Re: **Request for TEDS Exception for Access Location**

The purpose of this letter is to request an exception from *City of Grand Junction's Transportation Engineering Design Standards (TEDS) Section 4.1, Access Location*, for the site located on Lot 2 & 3 of CJM Subdivision, also known as 731 Scarlet Street, in Grand Junction, Colorado.

Re: Design Exception <sup>37-6</sup> 27-6 – 731 Scarlet Drive

**DESIGN EXCEPTION #<sup>37-06</sup>~~27-06~~**

**CUMMINS ROCKY MOUNTAIN**  
 CONCEPT PLAN  
 791 SCARLET STREET  
 GRAND JUNCTION, CO

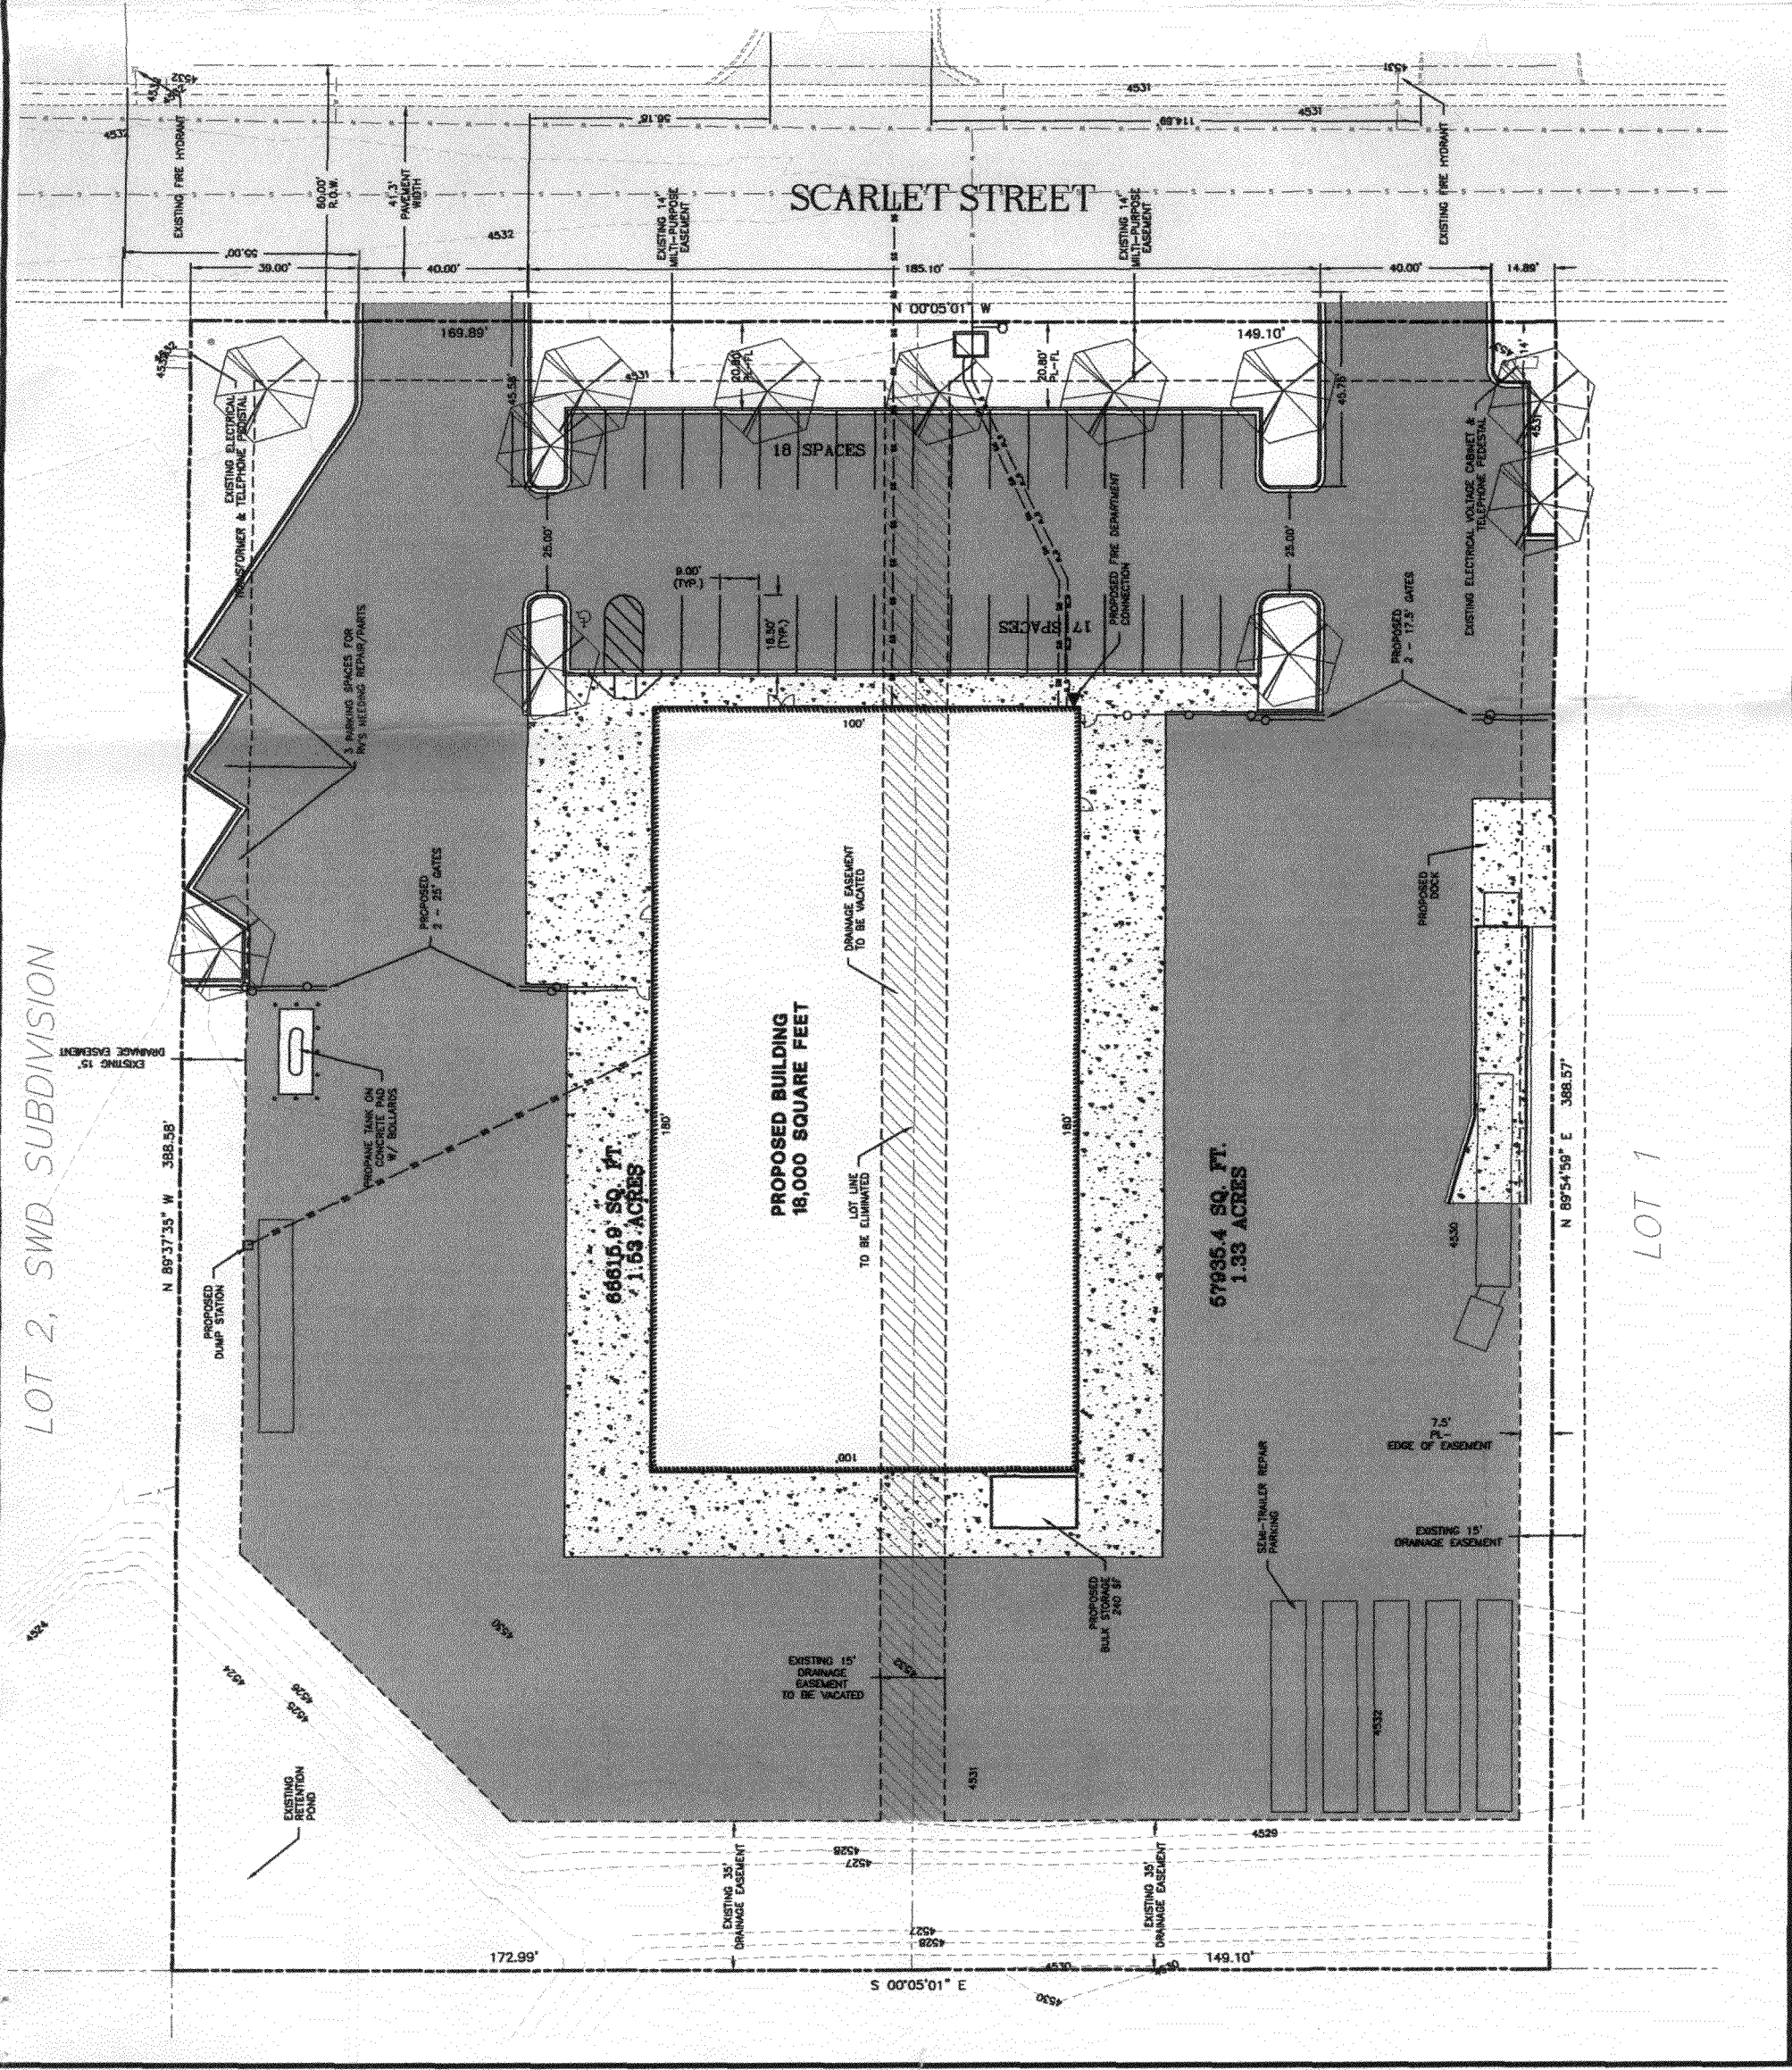
While the northern access has been located 50-ft or more from any existing adjacent driveways, the southern access does not meet TEDS requirements for access location as identified in Section 4.1. Existing structures and proposed traffic patterns on the site provide constraints that need to be taken into account as part of this exception request.

1. Existing Electrical Transformer & Telephone Pedestal prohibit shifting southern access closer to the southern property line.
2. Existing adjacent driveways along Scarlet Street.
3. Cummins Rocky Mountain, LLC provides repair service for large tractor trailers that require adequate enter and exit capacities to and from the site.

There are three options to address the minimum spacing for driveways. The first option is to relocate the existing electrical transformer and telephone pedestal and shift the access south to better align with the adjacent access. The second option is to completely remove the southern access. The third option is shift access to the north.

The first option, to relocate the existing electrical transformer and telephone pedestal to better align access with the adjacent access would result in an every expensive burden to Cummins Rocky Mountain, LLC. While this would locate the access closer to the adjacent access, it still wouldn't align directly across from it, thus not meeting TEDS requirement.

The second option, removing the access completely, would significantly limit access in and out of the site for the tractor trailers. It would require them to perform movements within the site that would be difficult and potentially dangerous.

The third option, locating the access to the north, would again not meet TEDS minimum spacing for access locations and result in a unsatisfactory site design.

The applicant is requesting variance from TEDS 4.1 Access location for opposing access spacing.

**1. Will the exception compromise safety?**

Staff does not believe the exception will compromise safety.

**2. Have other alternatives been considered that would meet the standard?**

Due to nature of the applicant's use of the site (with large trucks) a single, aligned access was not considered.

**3. Has the proposed design been used in other areas?**

The condition currently exists in several areas of similar low-volume industrial streets with no record of incident.

Please find attached the committee's decision for the above referenced request. This design exception has been approved as requested. You may use this decision to proceed through the development review process for this exception.

Staff recommends approval of the exception requested.
